MEMORANDUM

SUBJECT: The Grove staff review

SUBJECT: Proposed Grove Development
Technical Analysis Report On Traffic Review Process

CONCEPTUAL ROADWAY PLAN

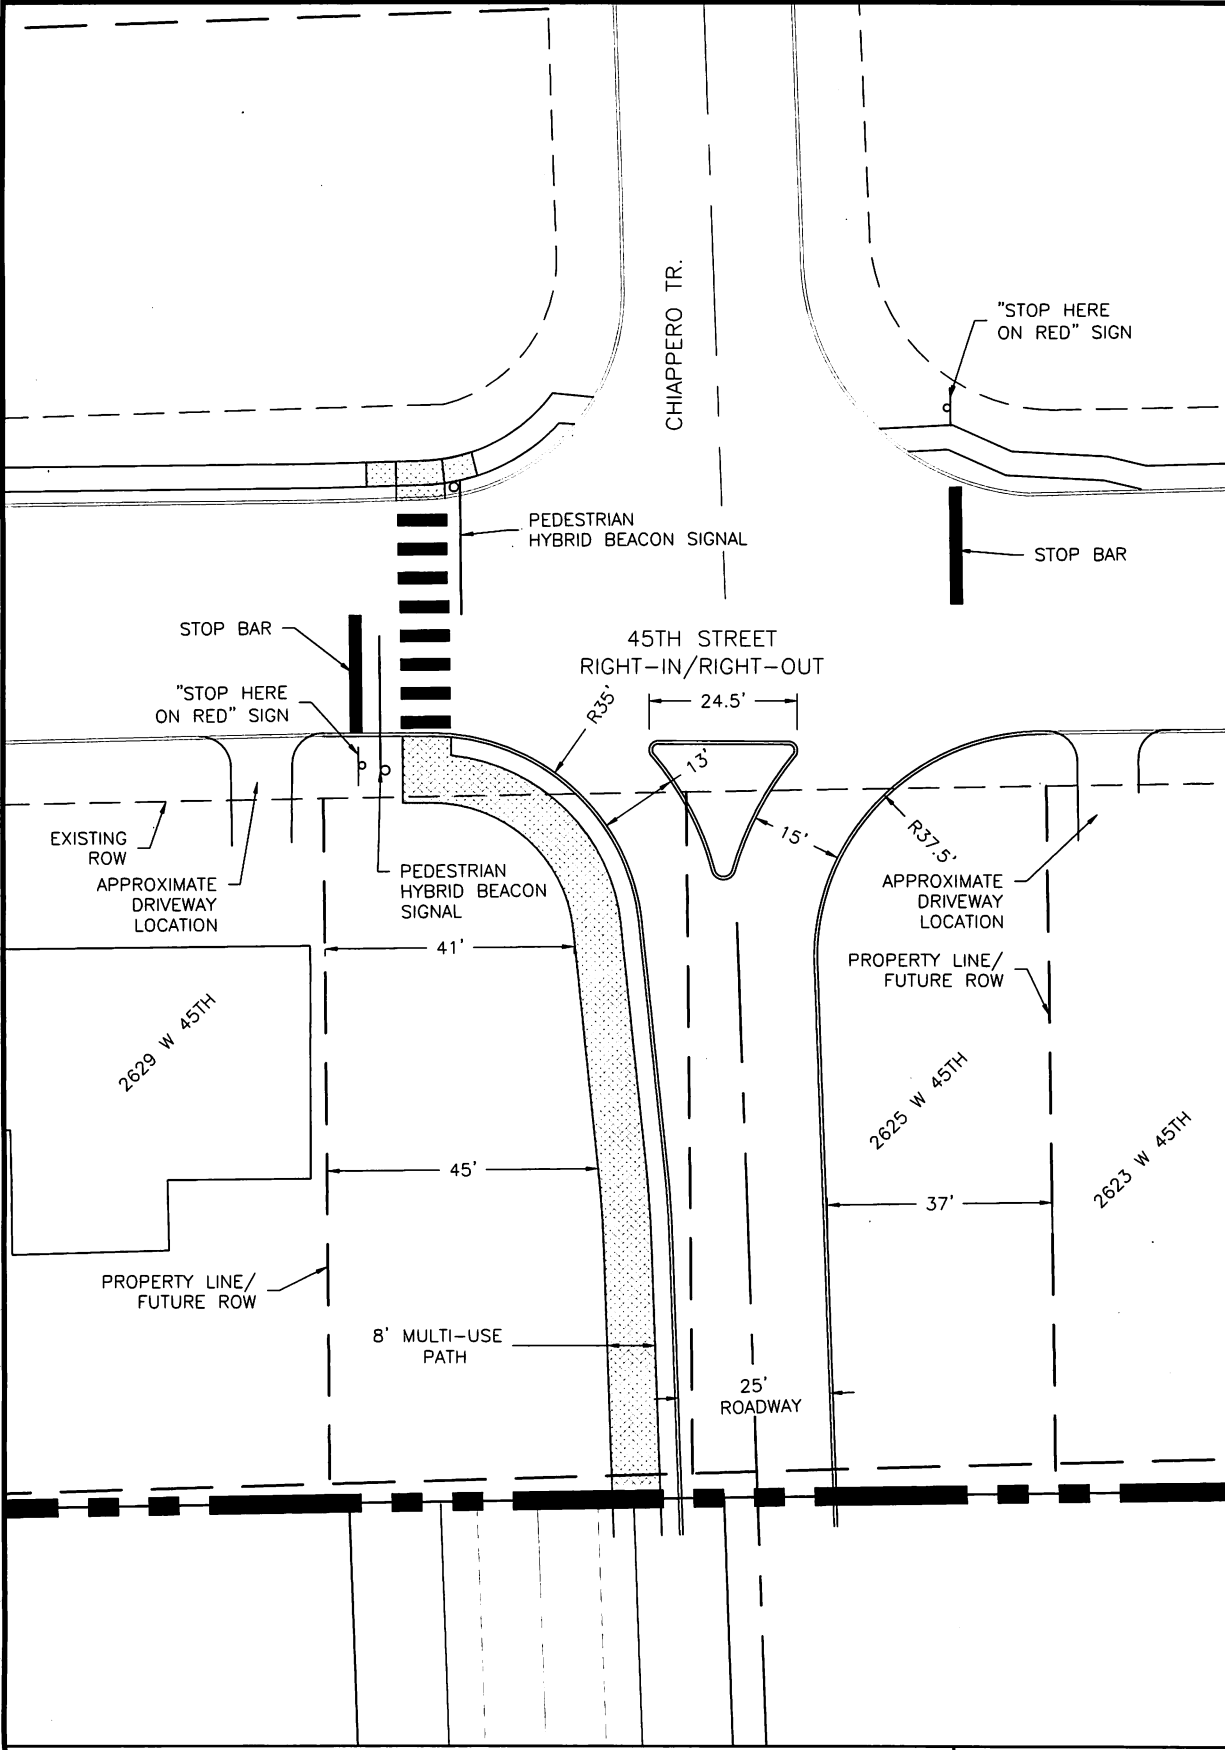
The Addendum was, therefore, submitted for the sole purpose of demonstrating that a 3-lane north bound Bull Creek Road alternative approach could mitigate traffic at the 45th Street and Bull Creek Road intersection without any right-of-way being required from the lot located at 2645 W. 45th Street. The Addendum only presented an alternative for staff to consider that did not involve right-of-way in an effort to answer any concerns about the unavailability of the right-of-way in the future.

Notwithstanding the foregoing, and for clarification, the most recently proposed intersection of Jackson Avenue and 45th Street that is being considered by staff simultaneously with the Addendum remains the Applicant's proposed configuration of that intersection. That proposed intersection will be (i) right-in, right-out only, and (ii) aligned with Chiappero Street, as depicted in the attached conceptual design. The City's TIA Memo calls for this connection, and the enclosed conceptual design was provided to staff to answer any questions over how this connection might occur. Withdrawal of the Addendum does not mean that this connection or the proposed configuration is also being withdrawn. The Applicant understands that the enclosed conceptual design of this intersection has, subject to review and approval of final construction drawings, been accepted by the City staff as a generally and conceptually feasible approach to this intersection.
